31 May 2019
Our Ref: 18044 Rev E

Re: Anglicare Bulli Village, Sandon Point

I respond to the traffic matters summarised in your correspondence dated 27 March 2019 (Appendix A).

SWEPT PATH ASSESSMENT

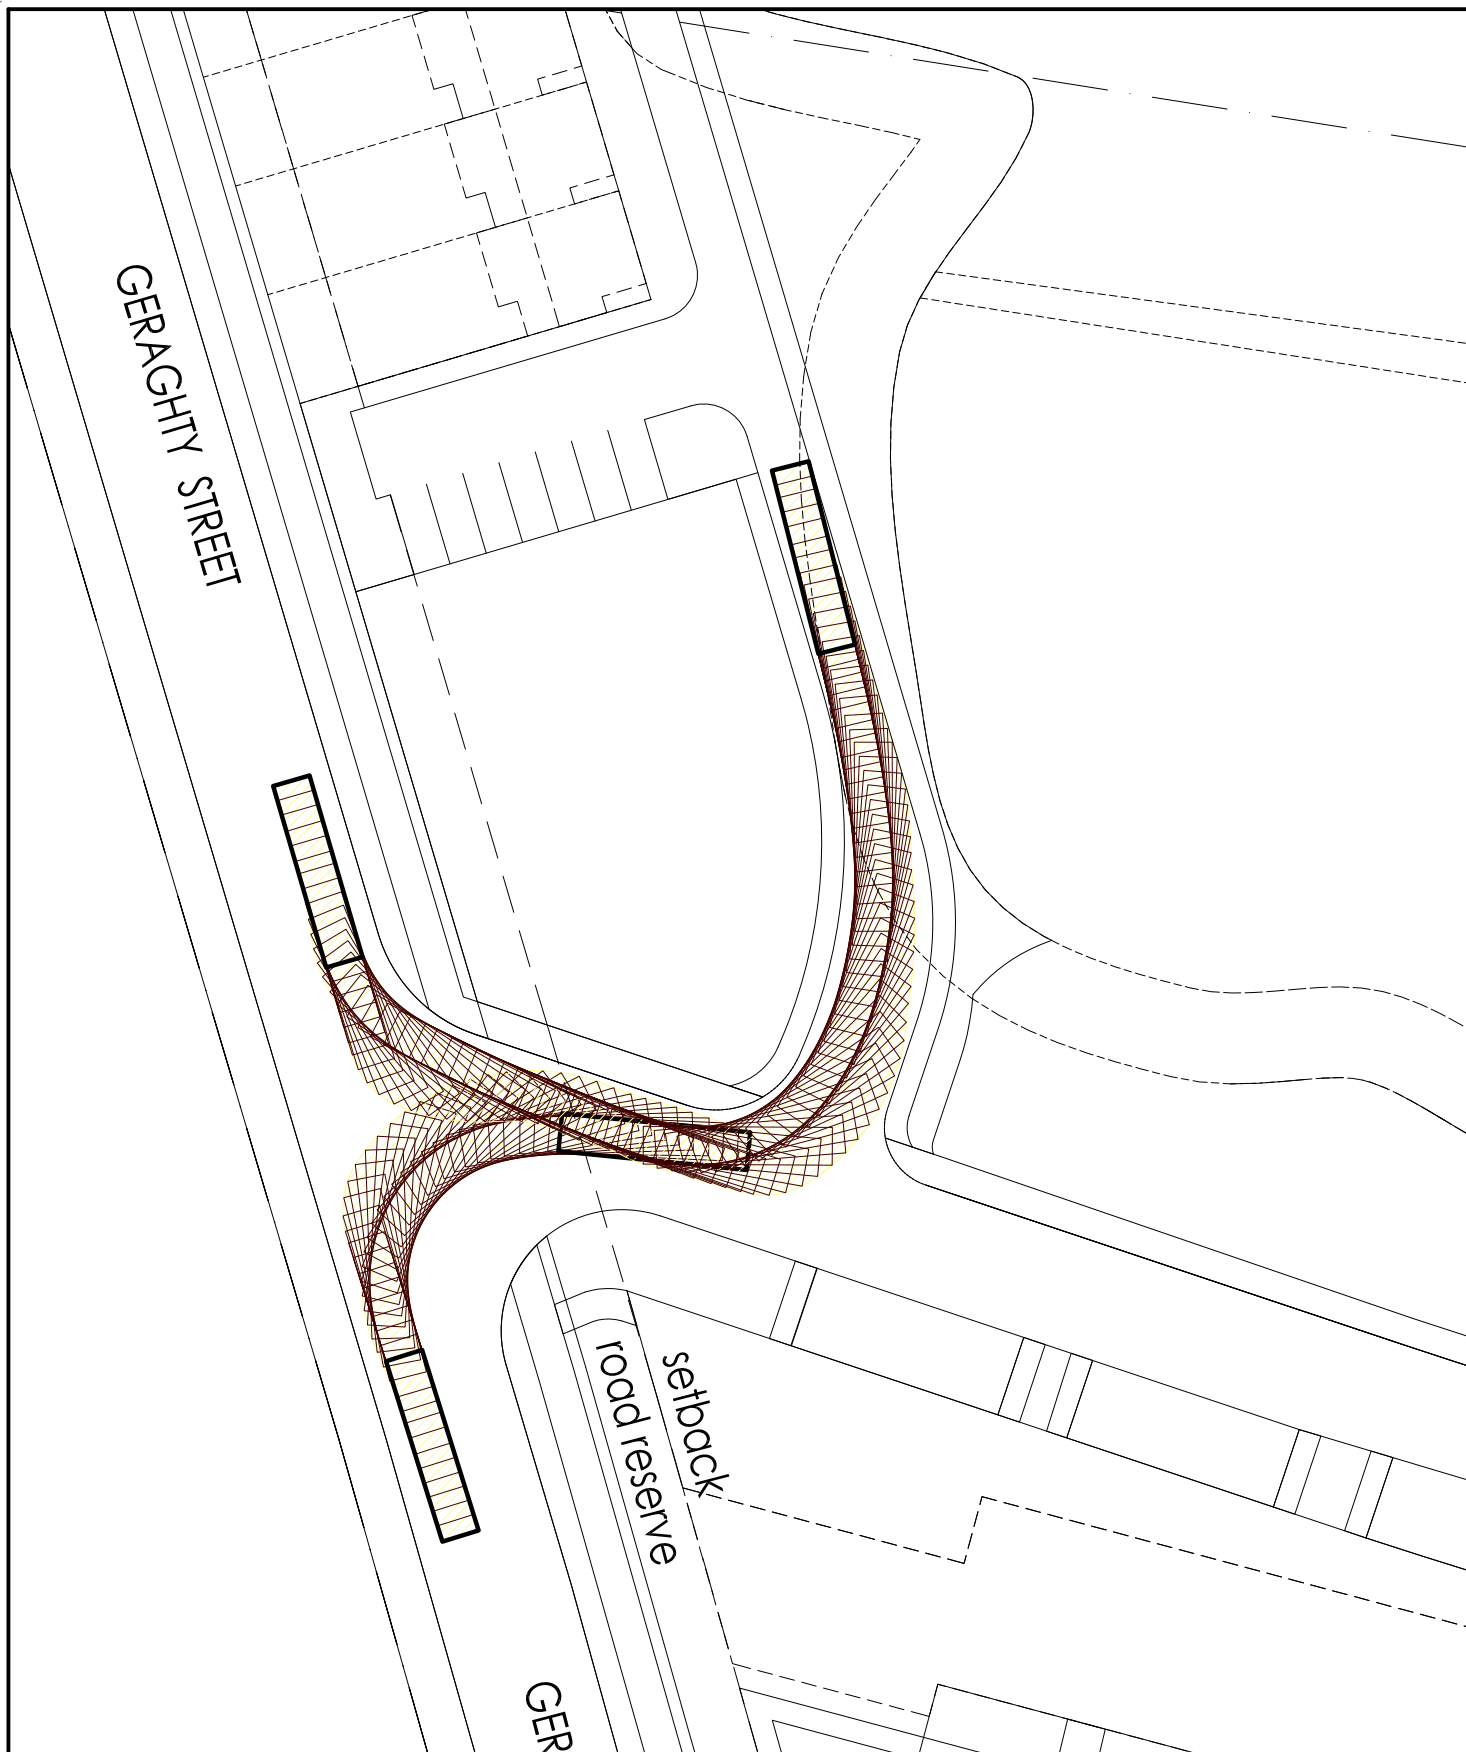
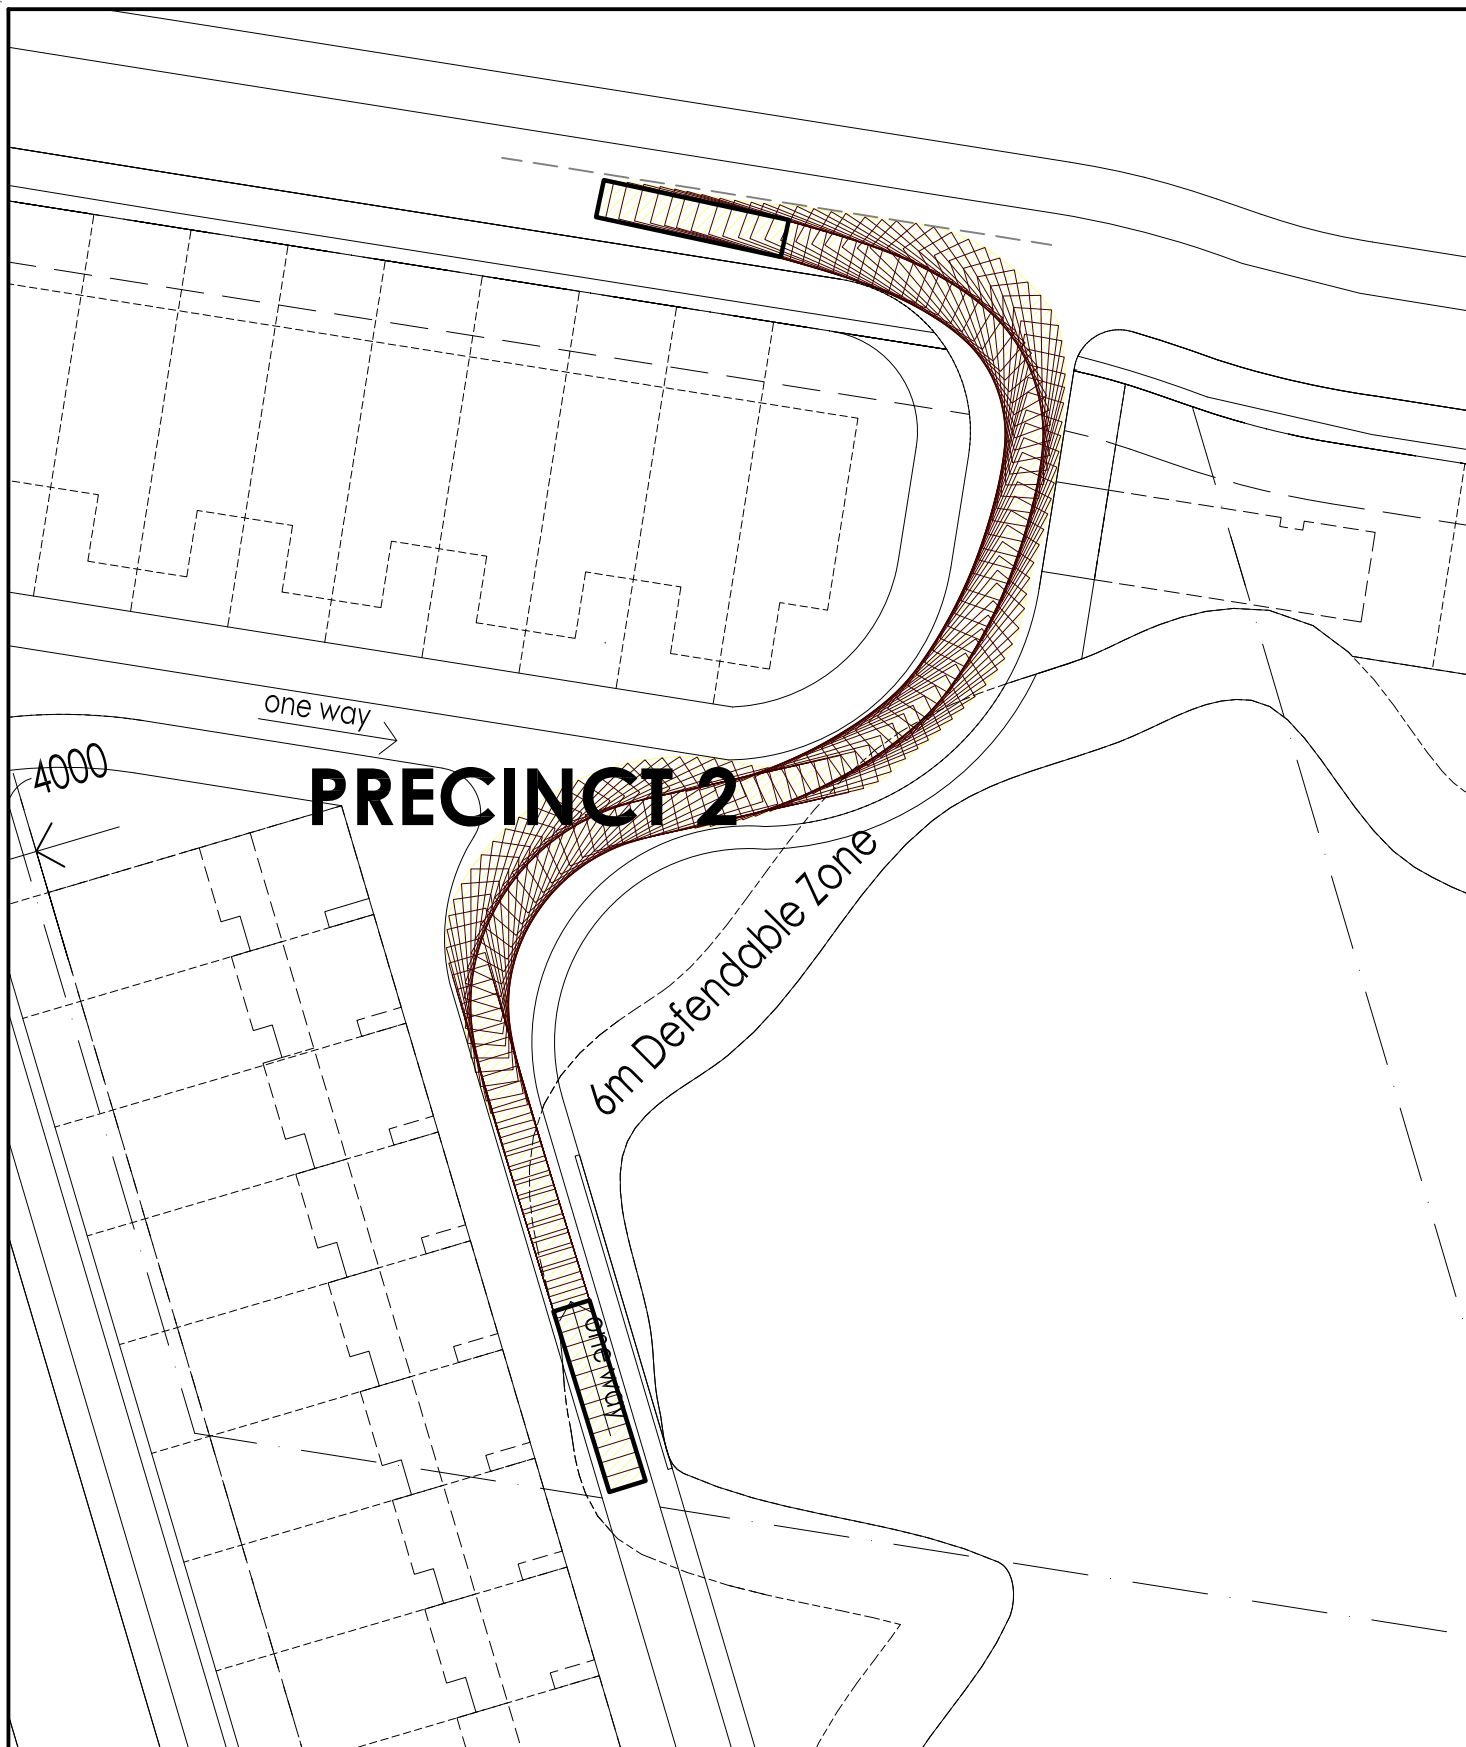
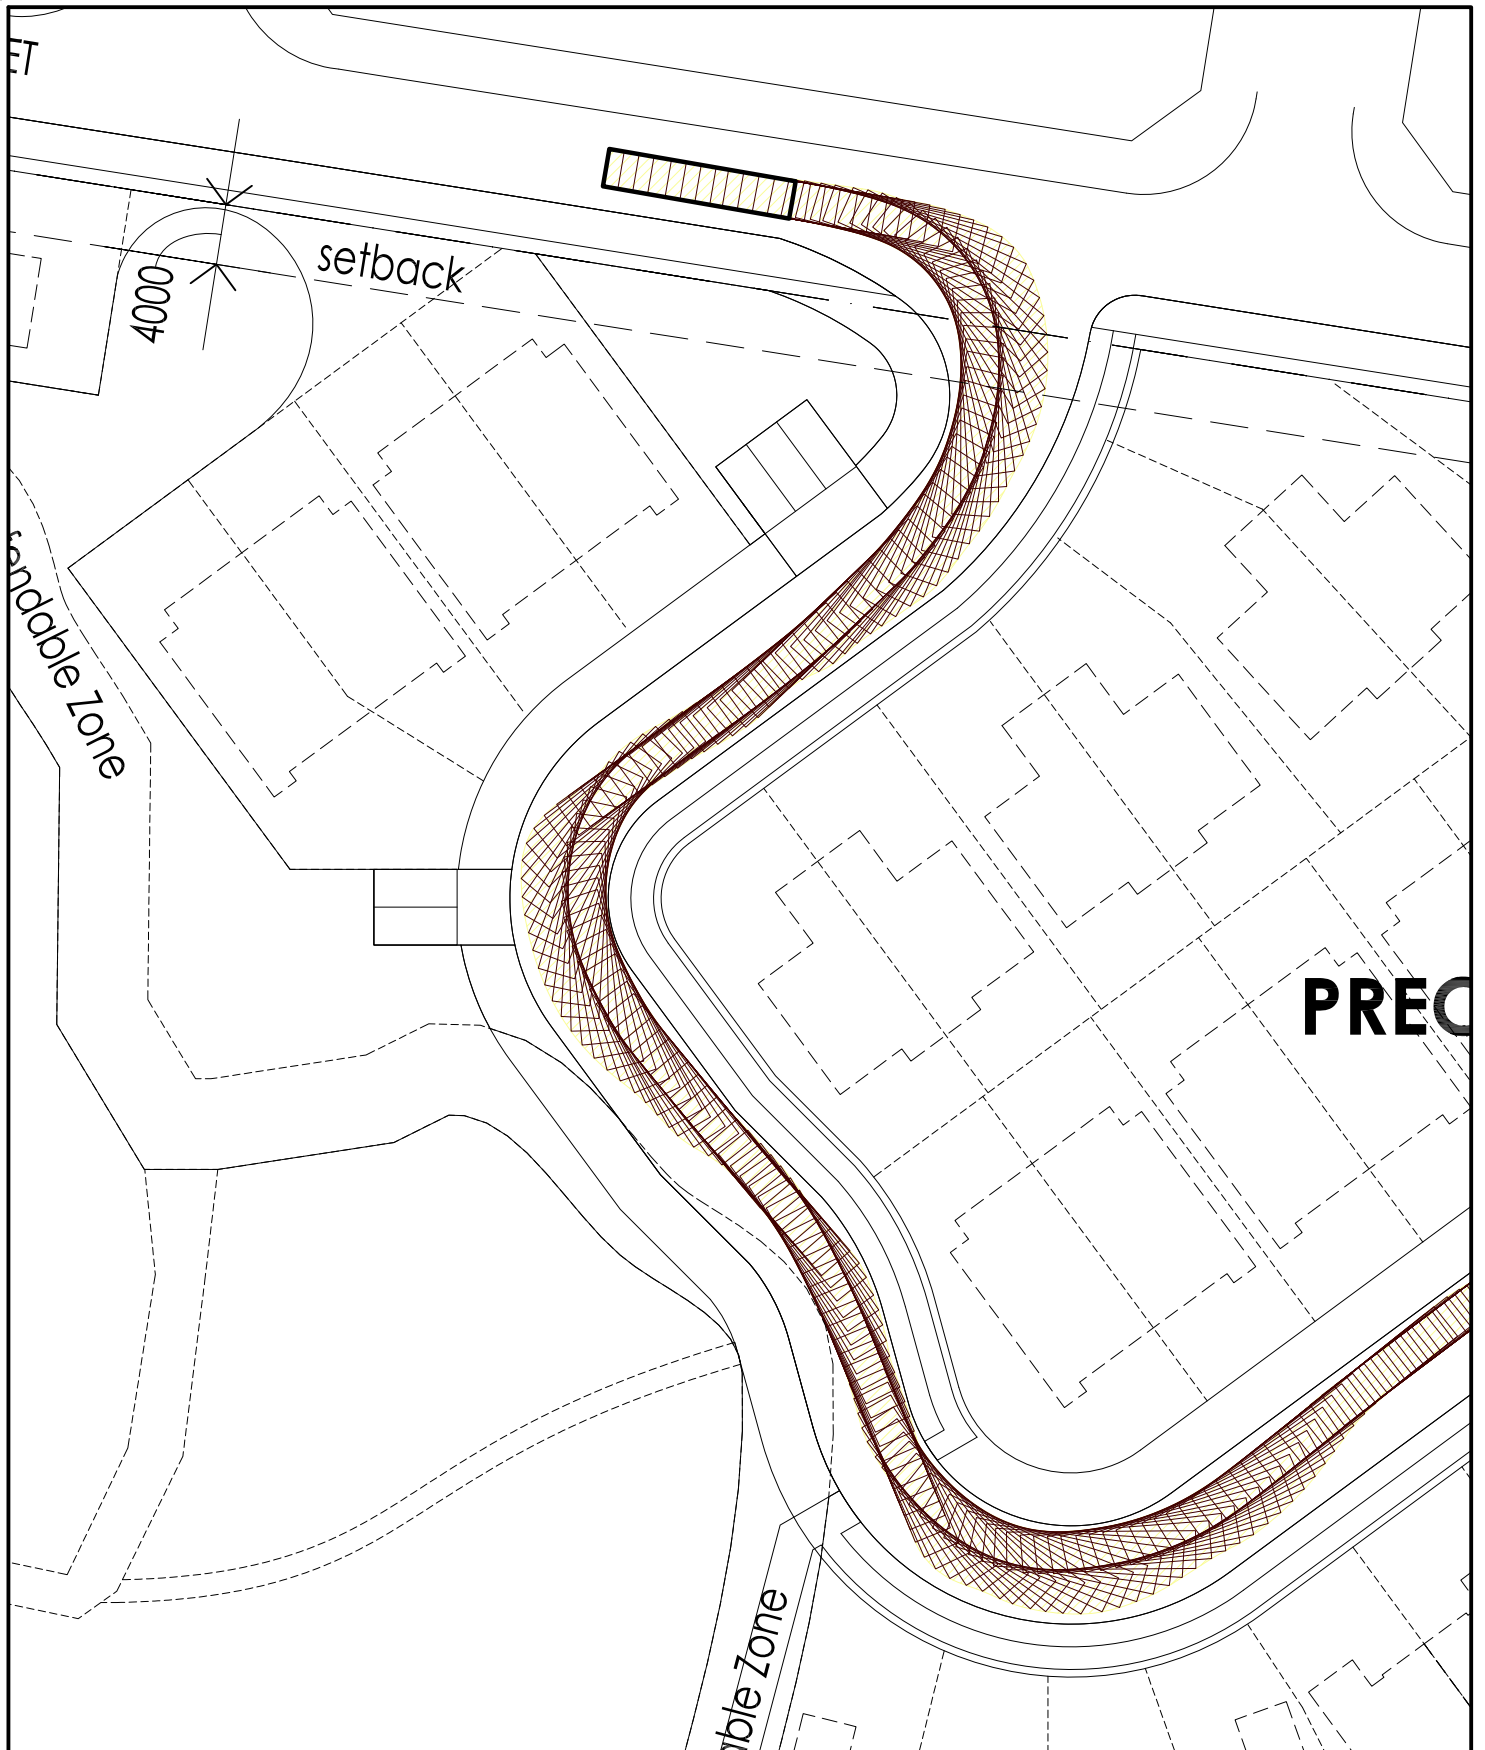
Concern is raised over the width of the proposed internal road network and the ability to carry out waste collection.

- The proposed garage widths will have regard for the AS2890.1 design requirements i.e. 3m minimum for a single vehicle garage and 6m for a double garage.
- Appropriate swept path assessment has been undertaken using 12.5m HRV at the entire estate's road network. Details of the assessment which demonstrate ability for the HRV (i.e. longer than Council's refuse vehicle of 10.2m) to negotiate the circulation roadways are provided in Appendix B. It is noted that the cul-de-sac is bounded by trafficable landscape features to accommodate the occasional truck manoeuvres.
- The parking requirements for visitors and residents for Seniors Living developments are subject to the SEPP criteria, not the DCP. As such, the SEPP requirement in this regard of 168 spaces will be accommodated for in the development. The proposed 51 residential dwellings will generate a parking

- The ILU cul-de-sac can accommodate the turning manoeuvre of a 12.5m HRV with no undue difficulty. Details of this provision are demonstrated on the swept path diagram in Appendix B.
